December 15, 2008
E-27377

Subject: Revision 1 to Transnuclear, Inc. (TN) Application for Amendment 1 to the NUHOMS® HD System, Response to Request for Additional Information (Docket No. 72-1030; TAC NO. L24153)

Reference: Letter from B. Jennifer Davis (NRC) to Donis Shaw (TN), "REQUEST FOR ADDITIONAL INFORMATION FOR REVIEW OF AMENDMENT 1 TO THE NUHOMS® HD SYSTEM (TAC NO. L24153), INCLUDING UPDATED REVIEW SCHEDULE," November 14, 2008

Figure 4.1 UO_2 Thermal Conductivity

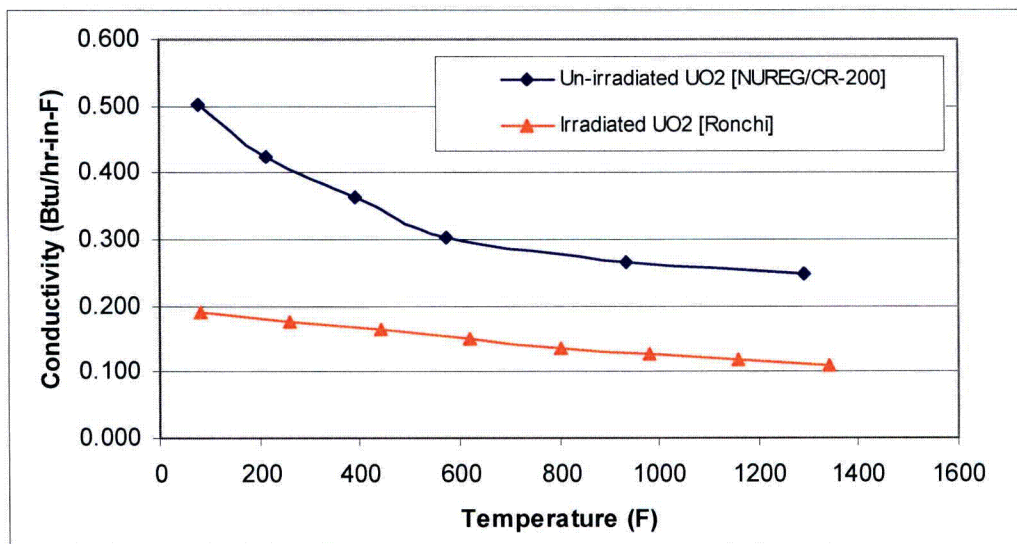
- 4.1 (SAR Section 4.8.2)** Provide a justification for use of the UO_2 material properties in Section 4.8.2 of the SAR. Update any analyses that rely on these values if any changes in the UO_2 material properties are warranted

TN reviewed the above references for the thermal conductivity of UO_2 . Based on the Ronchi study, UO_2 thermal conductivity of irradiated UO_2 with ~62 GWd/t and irradiation temperature $T_{irr} \geq 1300\text{K}$ (average T_{irr} for fuel pellet during irradiation according to M. Amaya et al.) drops significantly (more than 50%) compared to un-irradiated UO_2 . The thermal conductivity values of UO_2 in Section 4.8.2 of the SAR [NUREG/CR-0200, Revision 6, SAR Reference 4.30] are compared to the values obtained from the Ronchi study as shown in Figure 4.1. The comparison shows that the SAR values in the fuel assembly temperature of interest are higher by approximately a factor of two compared to values obtained from the Ronchi study.

Using irradiated UO_2 conductivity decreases the effective conductivity of the fuel assembly in the transverse direction. Note that as discussed in SAR Section 4.8.3.2, axial effective thermal conductivity of the fuel assembly is calculated based on the fuel cladding material only and does not include the UO_2 fuel pellet thermal conductivity. Therefore, the axial effective conductivity of the fuel assembly is not impacted.
